Access Compliance Report

Public Rights-of-Way

Intersection ID: 11929	Main Street: E_13TH_ST	Cross Street: N_DAVIDSON_ST	Location:	N
ADA ID: 5DF76FCE502F	Ramp Type: Perpendicular	Initial Pass/Fail: Fail	Overall Compliance: No	Severity Score: 25

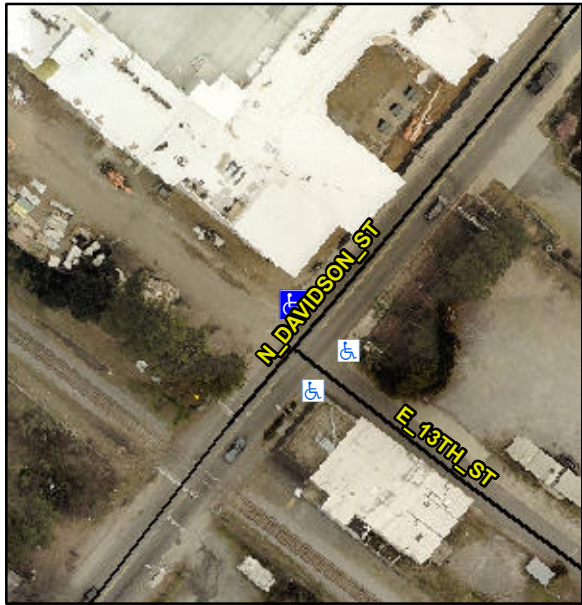
Codes/Mitigation Info/Possible Solution			Field Measurements/Component Compliance					
	Possible Solutions:		Compliance	Description	Data	Compliance	Description	Data
	Remove & Replace Entire Ramp.		N/A	Ramp Length (in)	30.0	Yes	Ramp Slope (%)	7.0
			Yes	Ramp Width (in)	60.0	No	Ramp XSlope (%)	8.6
			N/A	Flare Type LT	N/A	N/A	Flare Type RT	N/A
			N/A	Flare Slope LT (%)	N/A	N/A	Flare Slope RT (%)	N/A
			N/A	Flare Traversable LT?	N/A	N/A	Flare Traversable RT?	N/A
			N/A	Landing Length (in)	N/A	N/A	DWS Provided?	N/A
			N/A	Landing Width (in)	N/A	N/A	DWS Contrast?	N/A
			N/A	Landing Slope (%)	N/A	N/A	DWS Length (in)	N/A
			N/A	Landing X Slope (%)	N/A	N/A	DWS Full Width?	N/A
Surveyor Notes:			N/A	Landing Curb? (Y/N)	N/A	N/A	DWS Offset (in)	N/A
N/A			N/A	Shared Landing?	N/A			
PROW/ADA:			N/A	Gutter Ponding?	N/A	N/A	Gutter Slope (%)	N/A
R304.5.3			N/A	Gutter Lip Ht (in)	1.0	N/A	Gutter X Slope (%)	N/A
			N/A	Painted X Walk1?	No	N/A	Painted X Walk2?	N/A

X Walk 1 Direction	To SE		X Walk 2 Direction	N/A
			N/A	X Walk 1 Width (in)	N/A	N/A	X Walk 2 Width (in)	N/A
				X Walk 1 Slope (%)	10.1		X Walk 2 Slope (%)	N/A
				X Walk 1 X Slope (%)	5.8		X Walk 2 X Slope (%)	N/A
			N/A	Ramp inside XWalk1?	N/A	N/A	Ramp inside XWalk2?	N/A
				Road Slope (%)	N/A	N/A	Clear Space?	N/A
				Road X Slope (%)	N/A	N/A	Clear Space to XWalk (in)	N/A
			N/A	Any Obstructions?	N/A	N/A	Storm Grate/Utility Hazard?	N/A
				Obstruction Type			Storm Grate/Utility Type	
						N/A		N/A
						Yes	Surface Condition? (G/P)	Good
Total Cost:		\$ 1850.00
